回應渠務署的疑問

# A/TM-LTYT/476

## 回應運輸署的擬問

# 布局圖

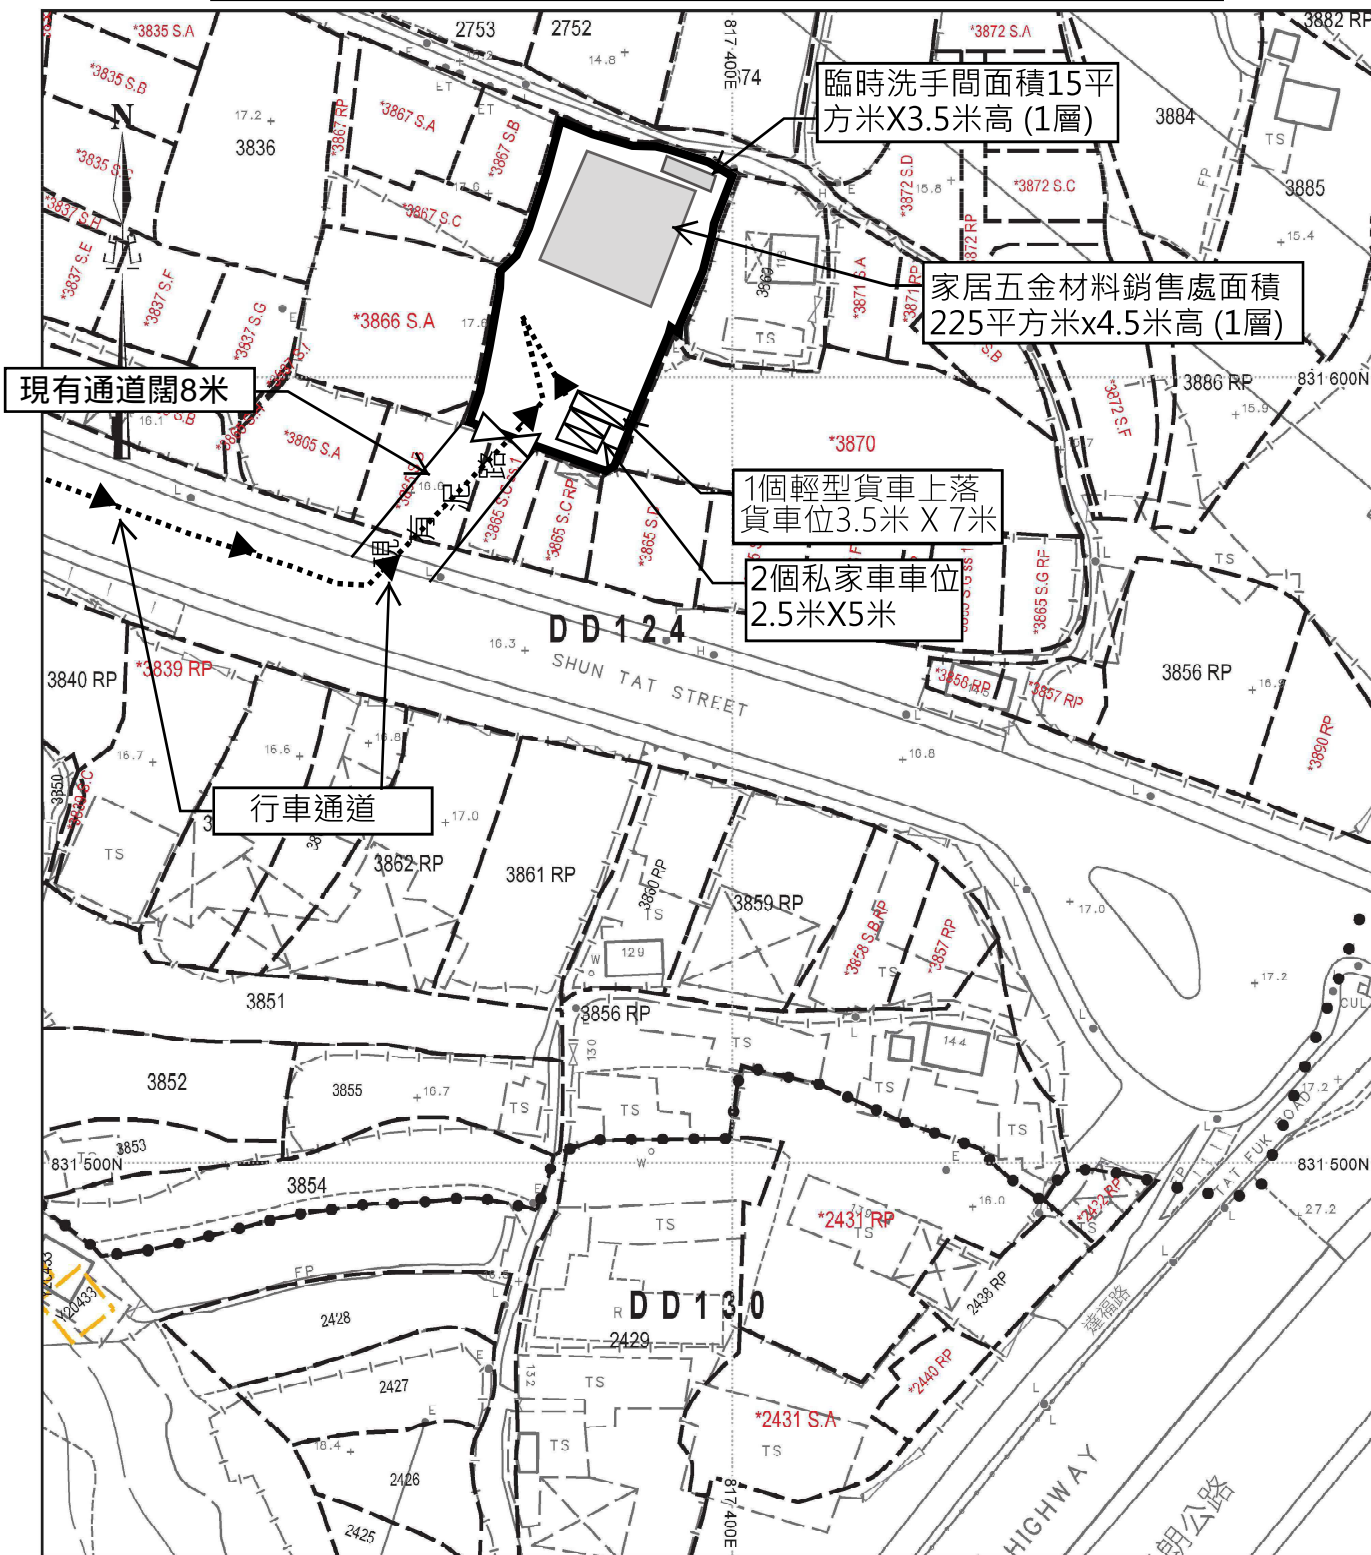
- b. Please clarify the width of vehicular access of the proposed site in the layout plan.  
有關出入通道闊8米，已更新布局圖，隨函一並附上新的布局圖
- c. Please advise the number of vehicular and pedestrian trip generation and attraction by the subject site.  
隨函附上車輛流量評估報告。

# 車輛進入模擬圖

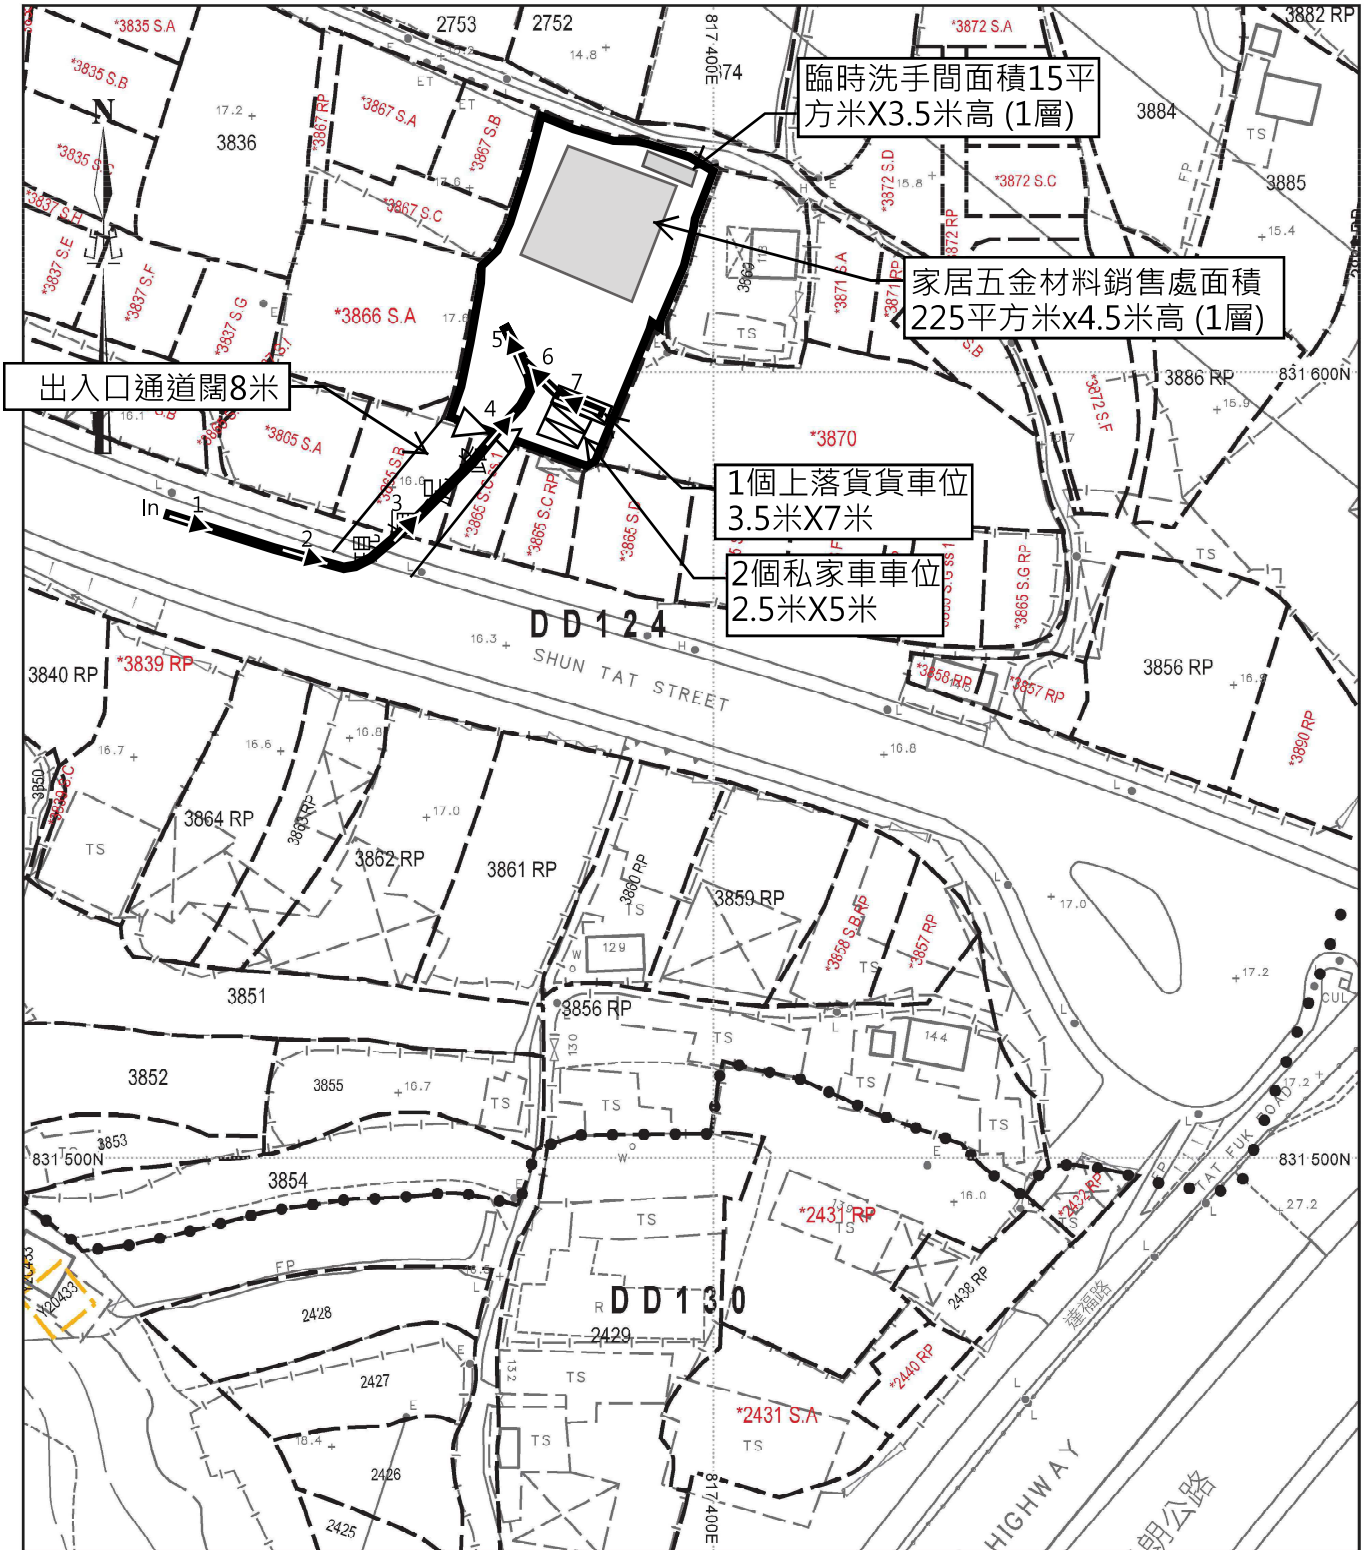
- f. Please supplement the swept paths showing the private cars (PCs) and light goods vehicles (LGVs) (i) entering the site from and leaving the site to Shun Tat Street via the private lots and the unallocated and unleased government land as stated in (a) above; (ii) manoeuvring within the open area of the site; and (iii) entering and leaving the PC and LGV parking spaces.  
我等隨函附上一份車輛進出模擬圖給貴署審議
